Planning and Zoning Commission Meeting

SITE IMPROVEMENT PLANS OTTO EXPRESS

4/23/26 Staff & Engineer Review

C1.1

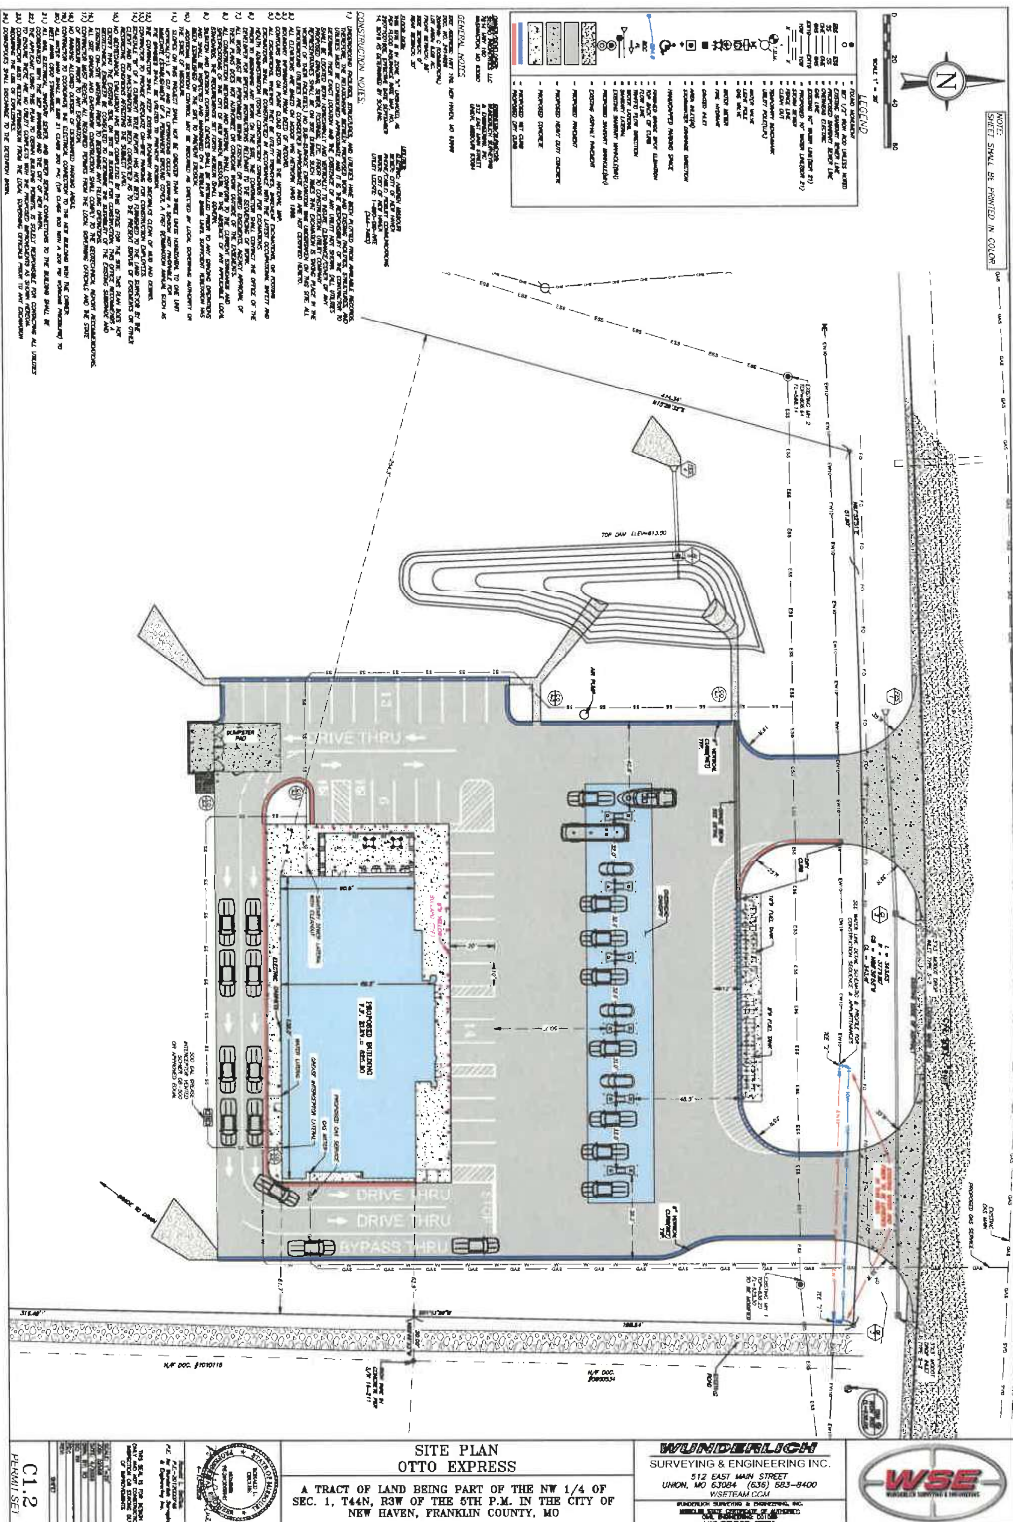
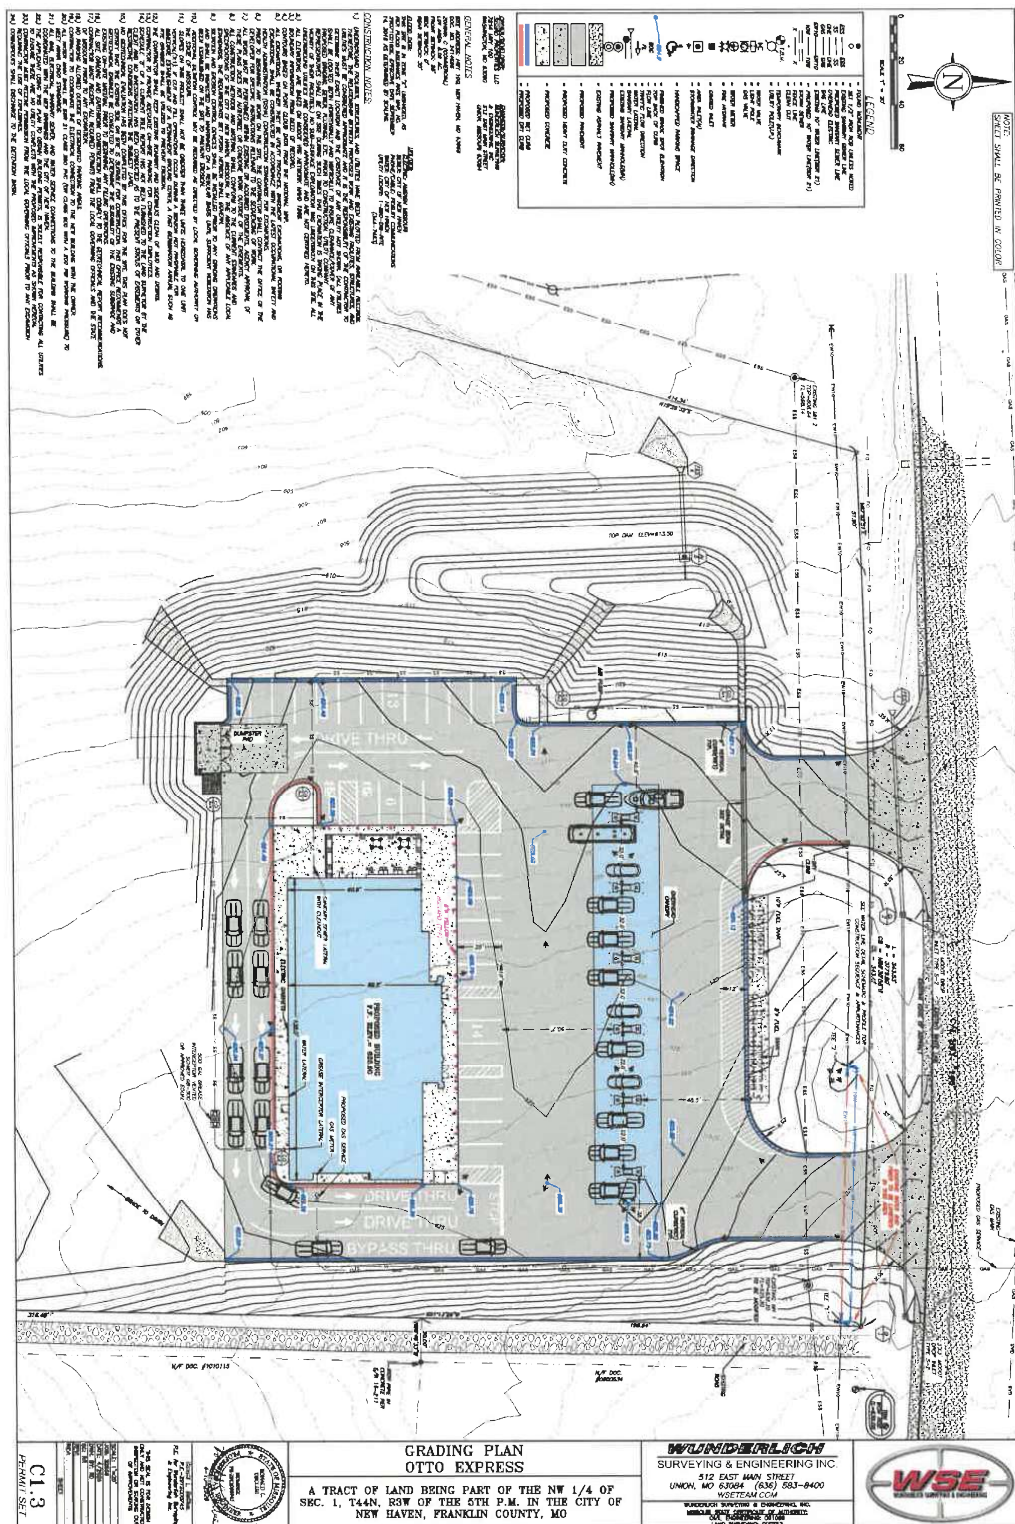
1. Indicate Name and Number of Utility Providers
2. Show adjacent properties information
3. Verify and show easements for water & sewer

1. Permit contingent upon MODOT entrance approval
2. Call out trash enclosure screening type, to meet city code
3. 405.710 Provide off street parking table & calculations per city code

4. 405.725 Provide lighting per city code
5. 405.730 Provide screening and landscaping per city code
6. Provide building square footage
7. Provide electric & transformer location

8. Provide water line size
9. Provide BTU's needed for gas service sizing
10. Show water service tee & valve at main connection
11. Public works require manhole at sanitary sewer connection

12. **Suggestions:**
 - a. Wye connections & cleanouts at sanitary sewer direction changes
 - b. ADA parking spaces & 2% cross slope verification & shortest path to entry, consider relocation of stalls to front of building, see marked up plans

- c. Consider adding stop signs and ground bars at highway entrances, ground markings at parking lot near drive thru entrance, see marked up plans

C1.3

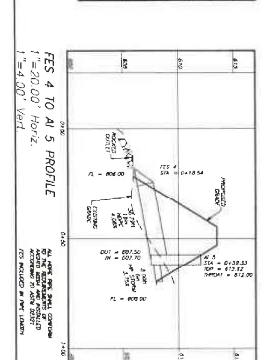
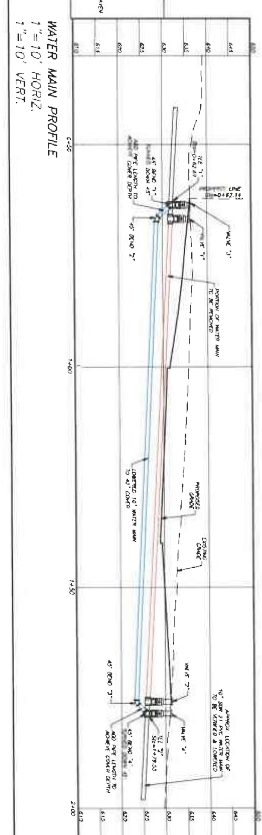
1. Permit contingent upon Missouri DNR Land Disturbance Permit issuance
2. Calculations show building draining to detention area, but no building drainage included in plans
3. **Suggestions:**
 - a. Consider additional grade beam at 2nd entry, to prevent flow under canopy
